Highgate School – Richard’s Music Centre – Carbon Management Planning Responses

Date
8th August 2025

On 10th April 2024, Haringey Council provided a Carbon Management Response (REF: HGY/2023/0315) which confirmed objection to the application. Within this, the Council stated that “*Carbon Management cannot currently support this application. Some clarifications must be provided with regard to the Energy Strategy, Overheating Strategy and Whole-life carbon Assessment. This should be addressed prior to the determination of the application.*” A meeting was held 10th March 2025 between AECOM, Highgate School, Haringey’s Carbon Management team and the Case Officer to discuss the response and comments by the Carbon Management team. AECOM has liaised with the design team in order to respond to the concerns raised. The response tracker below contains the concerns and queries raised by Haringey council and the design team responses to these.

Appendix 3 – Elevations detailing external louvres

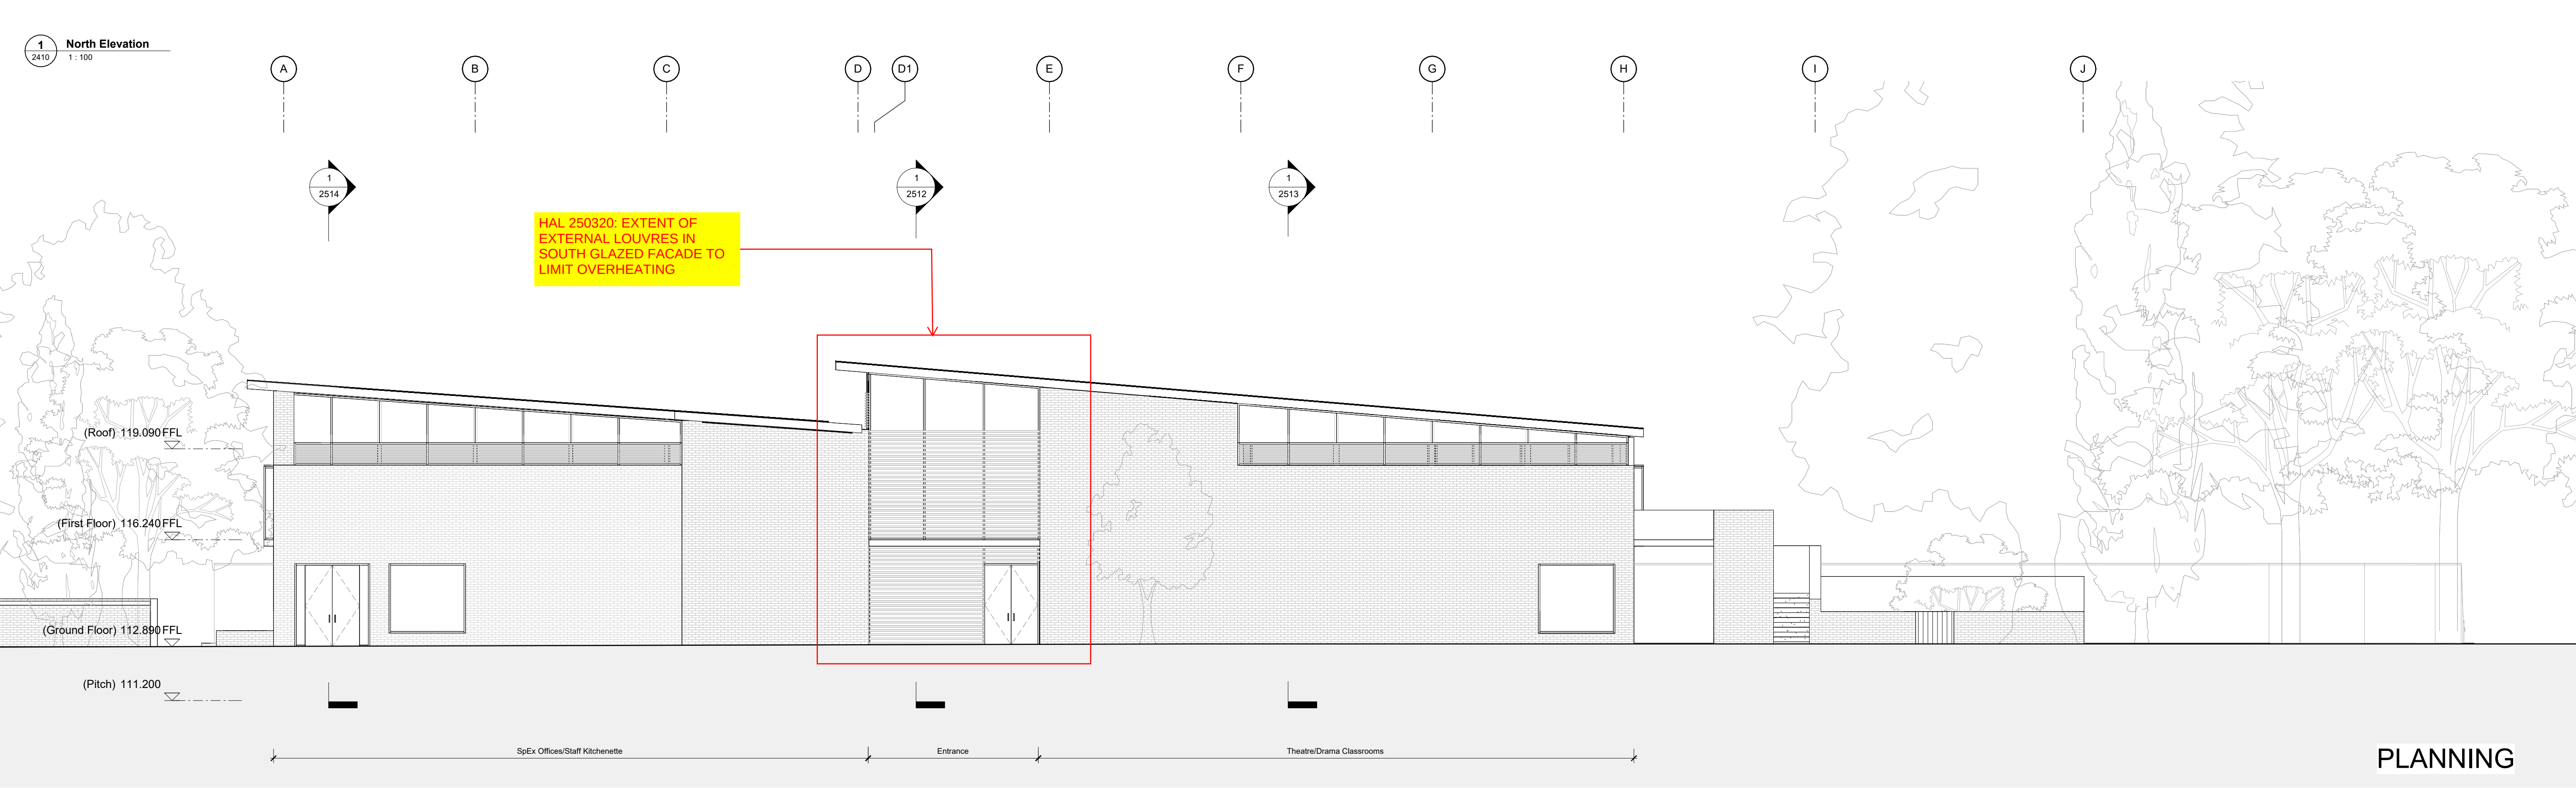
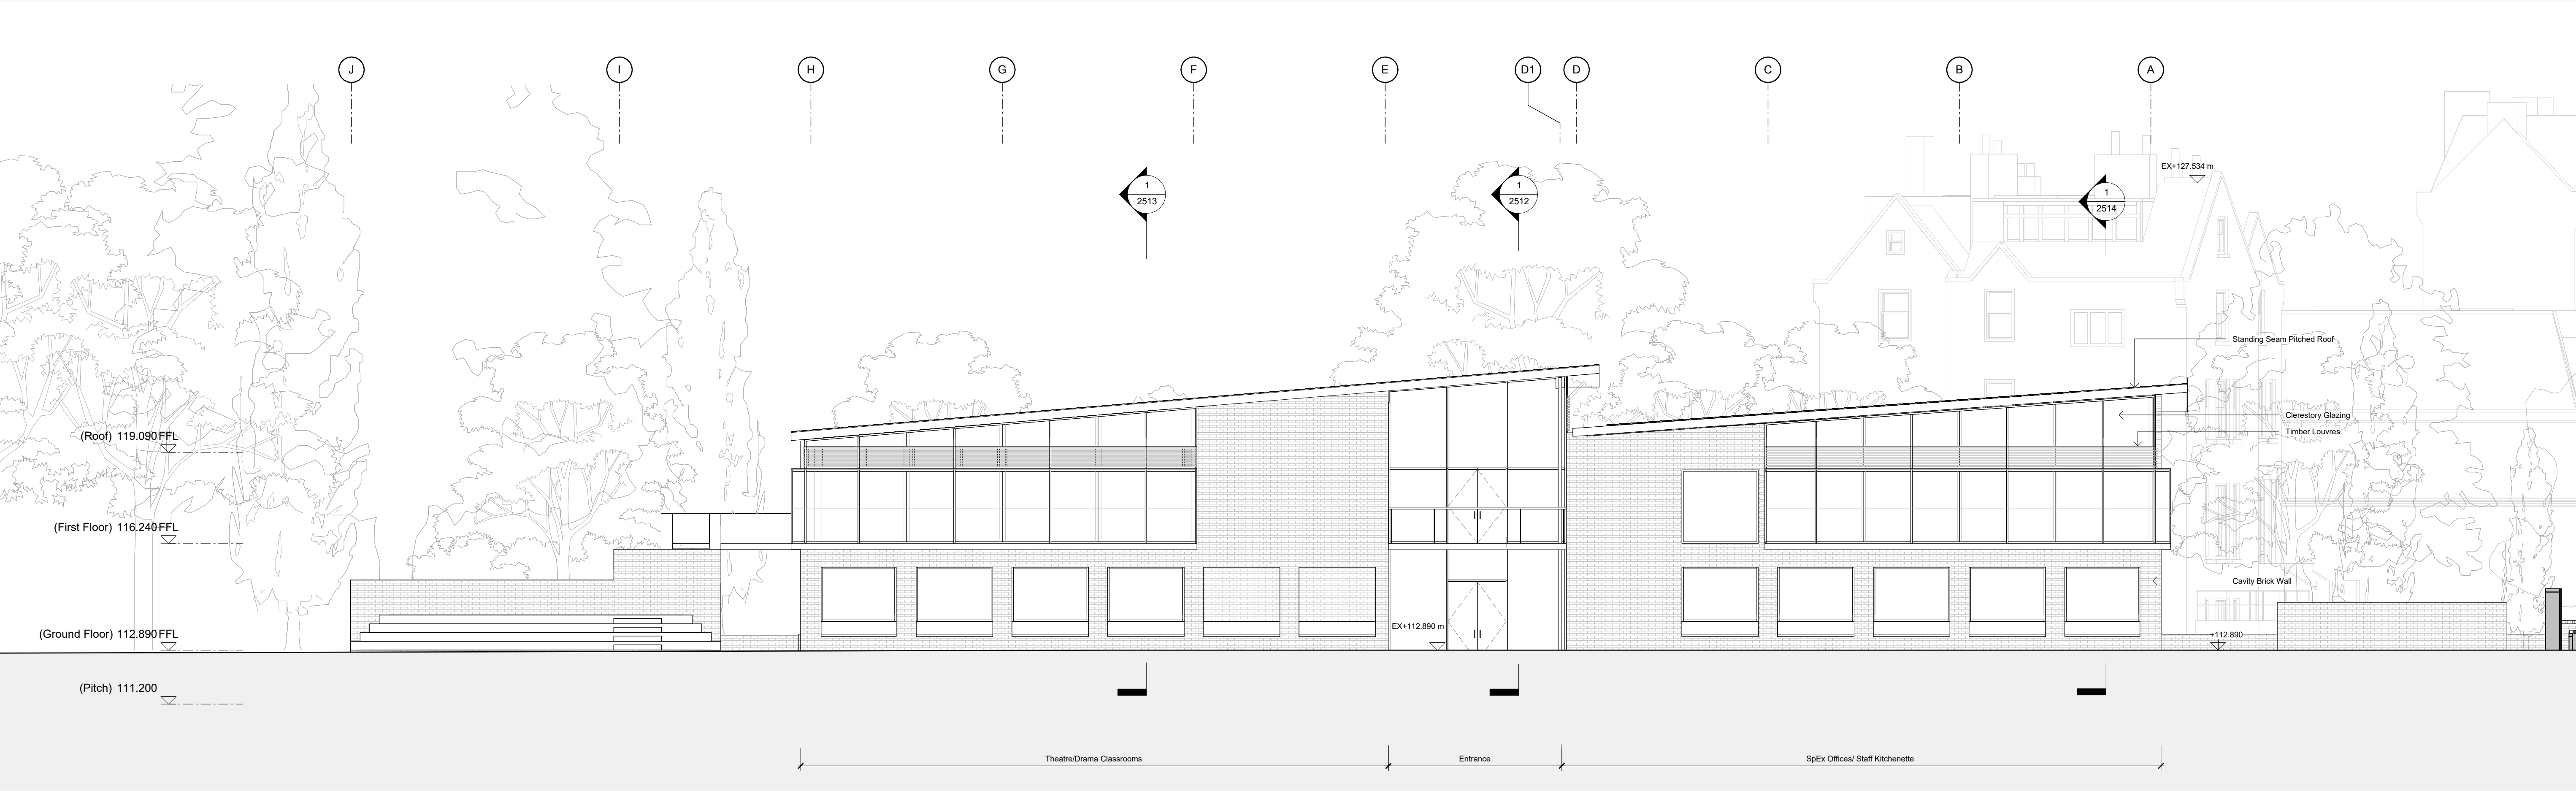
24.	Specify the shading strategy, including technical specification and images of the proposed shading feature (e.g. overhangs, Brise Soleil, external shutters), elevations and sections showing where these measures are proposed. Internal blinds cannot be used to pass the weather files but can form part of the delivered strategy to reduce overheating risk for occupants (as long as it does not compromise any ventilation requirements).	External louvres are proposed to be installed on the glazed façades. These louvres are a bespoke design integrated to the architecture of the façade of the building. There is no detailed technical specification developed at this stage of the project. The sections show the extent of external louvres on the southern and northern glazed façades. The southern façade is at higher risk of overheating therefore the proportion of glazed area covered is appropriate to prevent overheating. Details are shown in Appendix 4.
